**VALUE ENGINEERING STUDY
FOR**

**UPGRADE
PUMP STATIONS 2 AND 3
JEFFERSON PARISH, LA**

DOD SERVICE: USACE
CONTROL NO: CELMN-VE-98-01
VALUE ENGINEERING OFFICER: Frank Vicidomina

The Value Engineering Study was conducted in the New Orleans' District Office during the week of 6-10 October 1997. The study was based on the Concept (50%) Design Submission Reports, dated October 1997.

DRAWING NO. 2

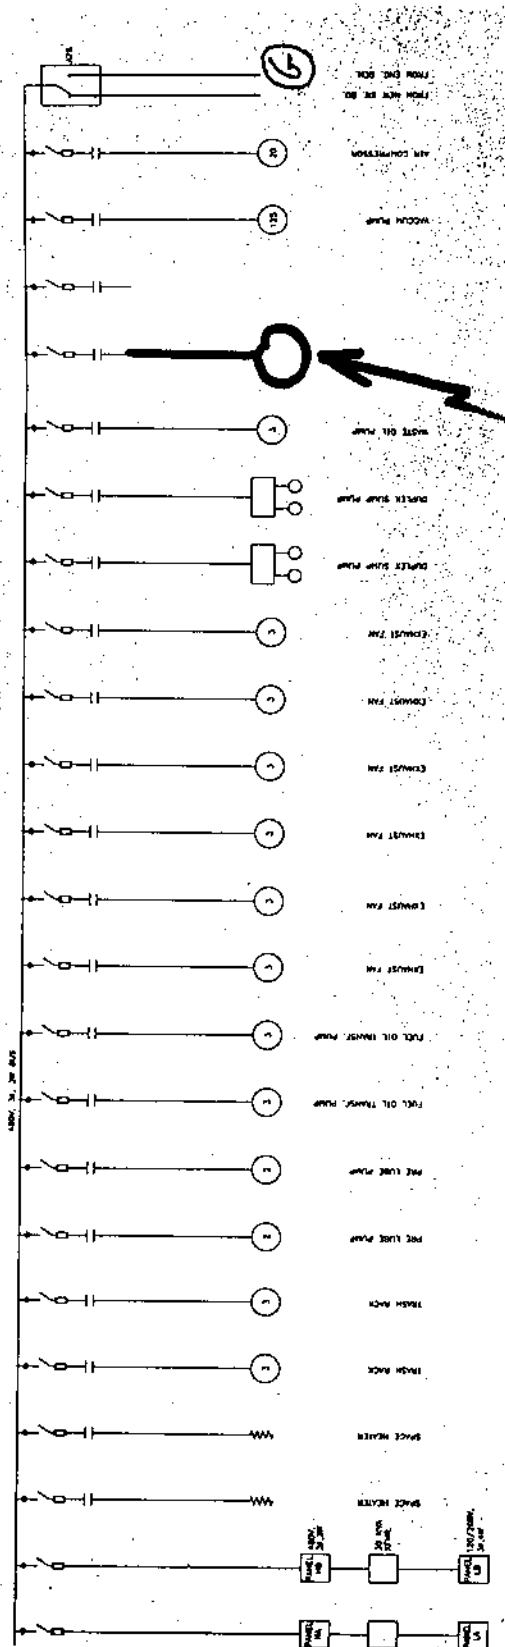
ADD WELL-PUMP LOAD

DRAWING NO. 1

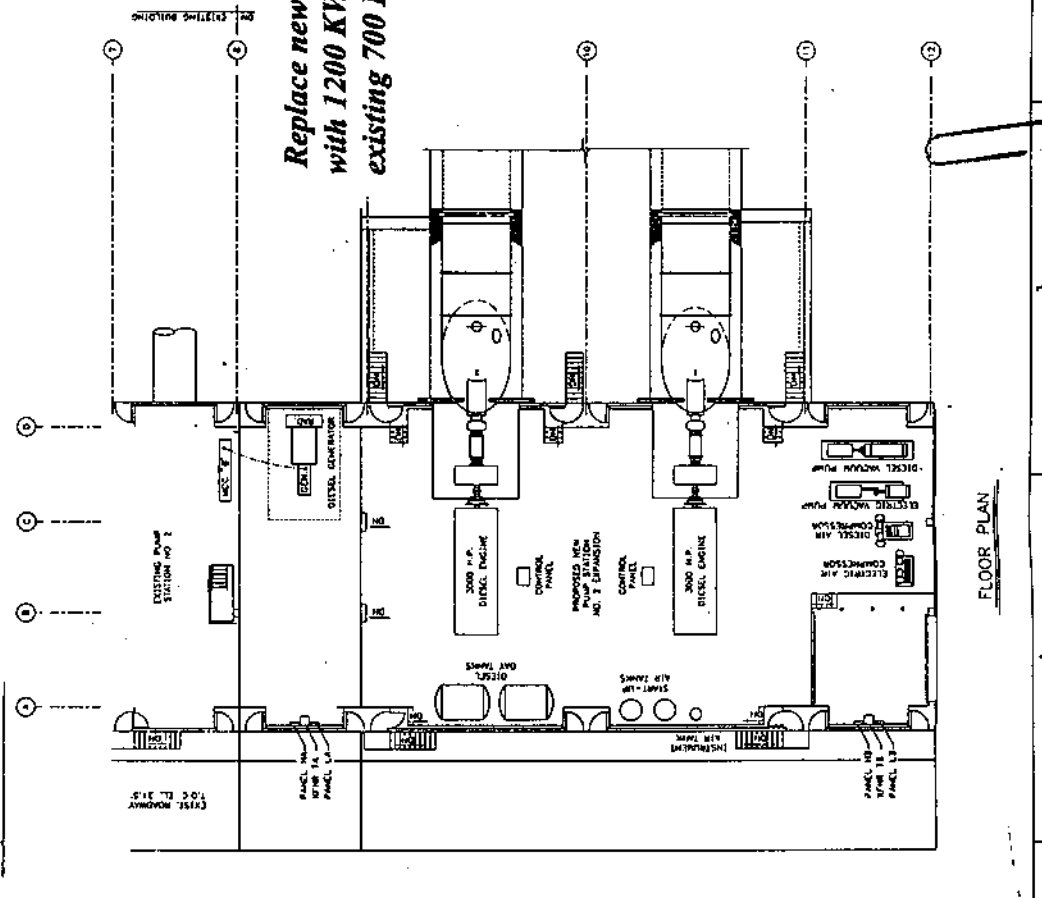
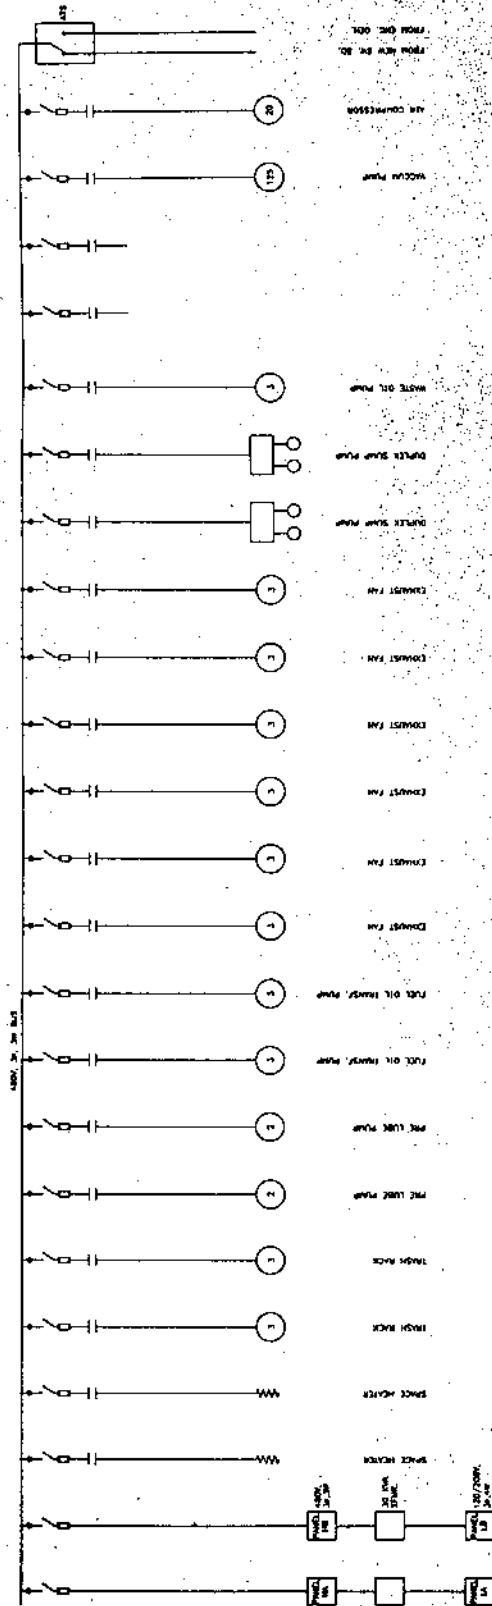
(See Drawing Nos. 1 and 2). The existing pump station contains two 400KW emergency generators. The new addition will add a new 400KW generator to feed a new motor control center, MCCB, to be located in the existing plant. MCCB is to feed the start-up equipment in the new addition. The new design load for the addition appears to be about 300KW+/- (See Drawing. No 2). There also currently exists an electric motor-driven pump at the plant, capable of about 300 CFS.

(See Drawing Nos. 1 and 2). This proposal suggests providing a new 1200KW emergency generator at Pump Station No 2. In addition to serving as the emergency generator, this new generator will have the capability to run the 700 HP electric pump. This would eliminate the need to purchase a new 400KW emergency generator. It would also free-up one of the existing 400 KW generators to be used at Pump Station No. 3. The remaining 400KW generator could remain as a back-up.

*Replace new 400KW Gen in Existing Design
with 1200 KW Gen to feed MCCB and
existing 700 HP Electric Pump Motor*

DRAWING NO. 1

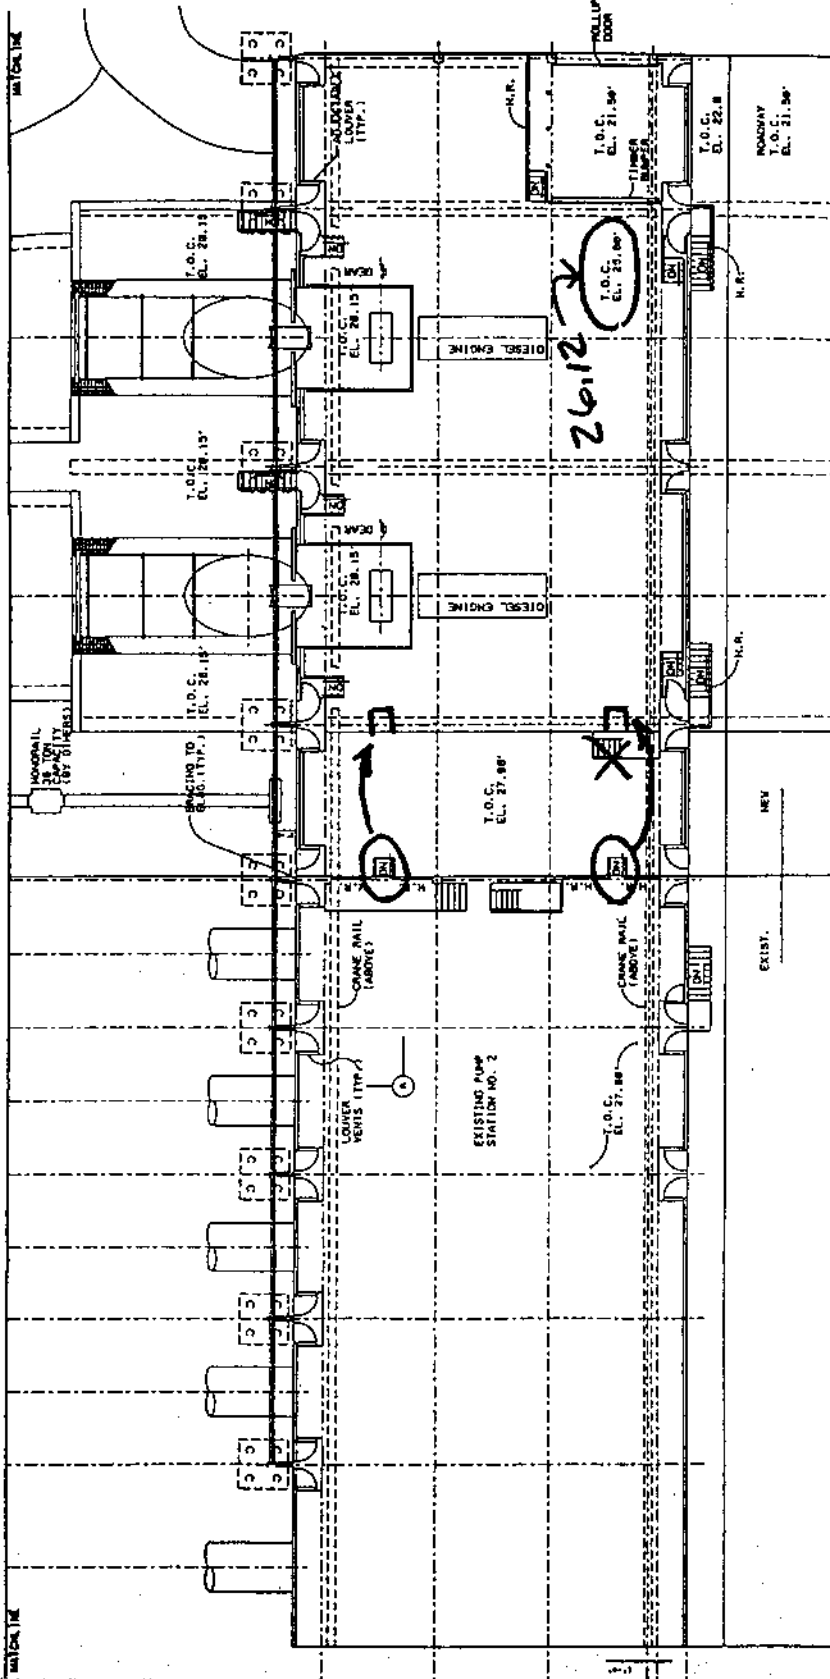
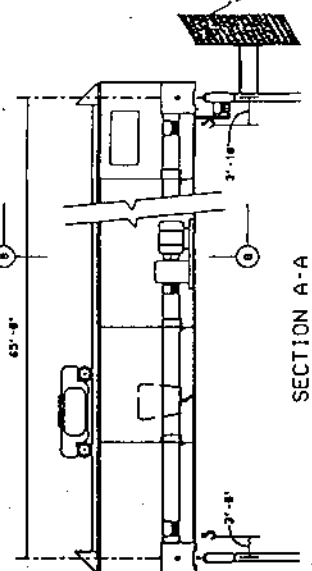
12. **Heads Up -- Revise Plate 3, H-2-44957** -- T.O.C. elevations are incorrectly labeled, as well as stair locations (see Drawing No. 1).
